Company	Trenz Electronic GmbH
PCN Number	PCN-20251025
Title	TE0813 Gap Filler Upgrade
Subject	BOM Change
Issue Date	2025-11-05

This change affects all TE0813-02 variants with preassembled heatspreader: TE0813-02-xxxxxxxK.

#1 Changed gap filler from GF3500S35-00-60-50CC to GF4500CVO-00-240-50CC.

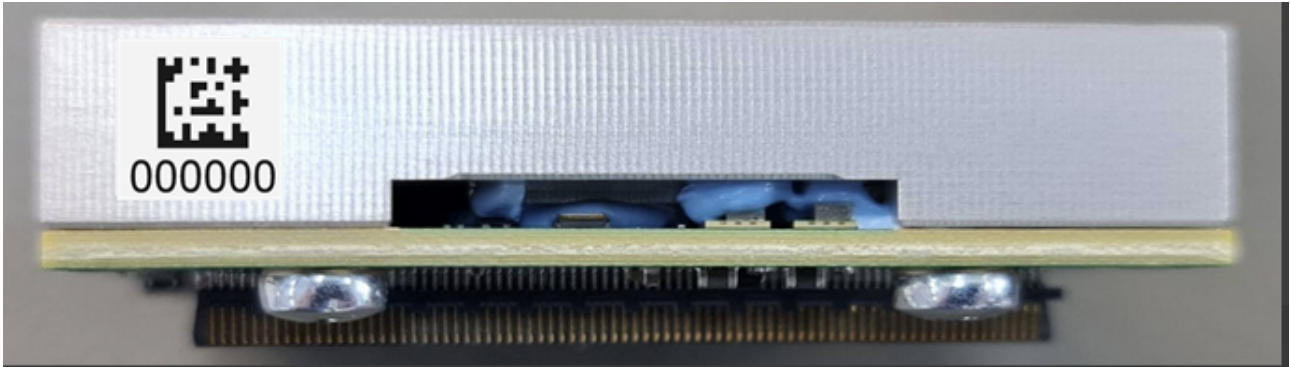
Reason: Improve thermal conductivity.

Impact: Improved thermal conductivity. Changed colour from blue to pink. For more detailed changes consult gap filler datasheets.
